# DART SERVICE INSTRUCTION

TO AMEND INSTALLATION INSTRUCTIONS IIN-D119-827 REV. E OR LATER APPROVED REVISION AND  
INSTRUCTIONS FOR CONTINUED AIRWORTHINESS ICA-D119-827 REV. 3 OR LATER APPROVED  
REVISION

A	NEW ISSUE, REF CAR17-209		VS	17.12.08
REV.	DESCRIPTION		BY	DATE
DESIGN	VS	<b>DART AEROSPACE USA, INC.</b> EUGENE, OR		
DRAWN	VS	DRAWING NO. <b>DSI 9795</b>		
CHECKED	WK	REV. A SHEET 1 OF 2		
MFG. APPR.	N/A	TITLE <b>PEDAL LOCKOUT INSTALL</b>		
APPROVED	HS	SCALE NTS		
DE APPR.	DS	PEDAL LOCKOUT INSTALL		
DATE	17.12.08	COPRIGHT © 2017 BY DART AEROSPACE USA, INC. THIS DOCUMENT IS PRIVATE AND CONFIDENTIAL AND IS SUPPLIED ON THE EXPRESS CONDITION THAT IT IS NOT TO BE USED FOR ANY PURPOSE OR COPIED OR COMMUNICATED TO ANY OTHER PERSON WITHOUT WRITTEN PERMISSION FROM DART AEROSPACE USA, INC.

FIGURE 1 - 109-0041-02-121 PEDAL SUPPORT

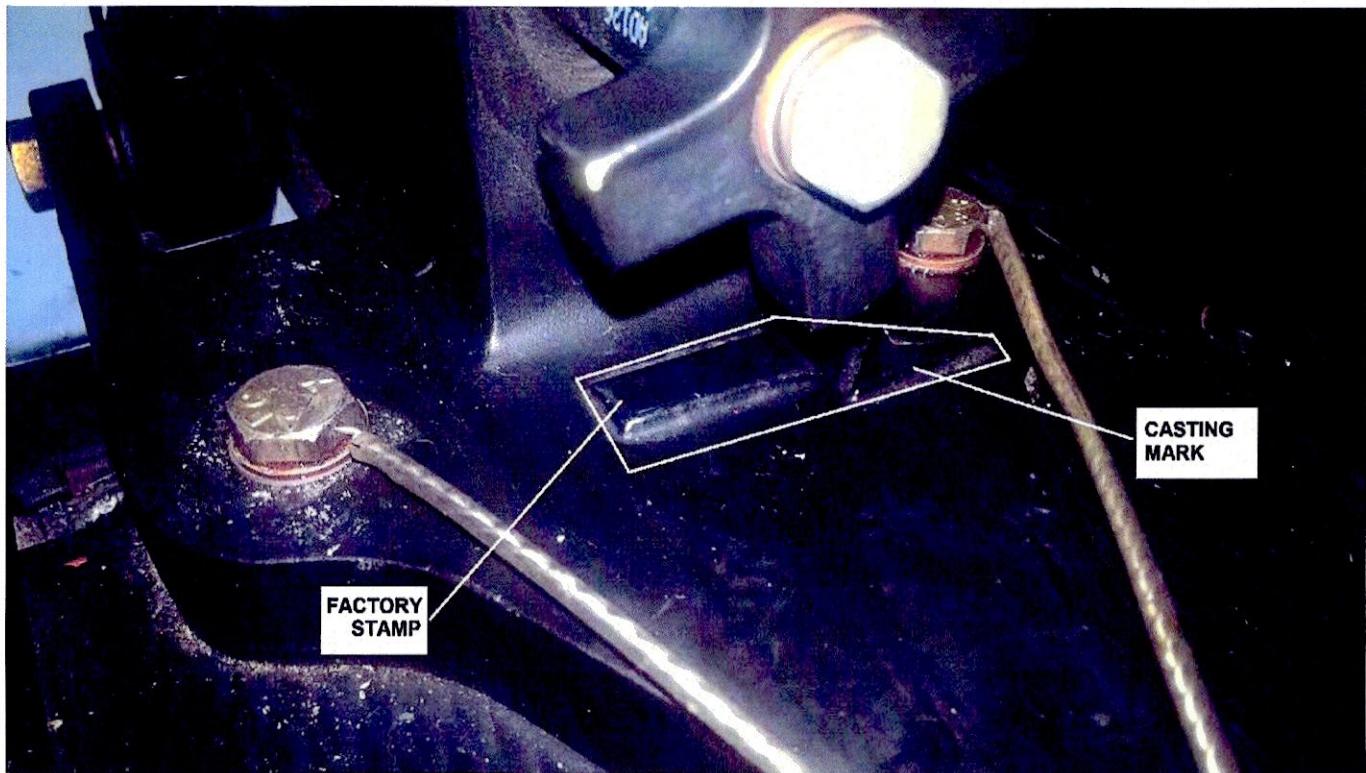
It has come to DART's attention that casting marks or other markings on the 109-0041-02-121 Pedal Support may interfere with the installation of the D109-827-013 Tail Rotor Pedal Lockout kit when installed on the AW109SP aircraft models.

3.1 If the casting mark, factory stamp or other factory markings on the 109-0041-02-121 Pedal Support shown in Figure 1 is interfering with the D109-827-013 Tail Rotor Pedal Lockout kit installation, they may be buffed until flush with the surface.

NOTE: Before buffing the factory stamp, record all data (ie: part number, serial number, etc) elsewhere on the 109-0041-02-121 Pedal Support with a white paint marker.

3.2 Touch up the buffed area according to AMS-M-3171 Type VI using MIL-P-23377F Type I Class 1 or MIL-PRF-23377 Type I Class C2 Primer. Touch up paint finish using MIL-PRF-22750 epoxy topcoat matte black FED-STD-595 No. 37038.
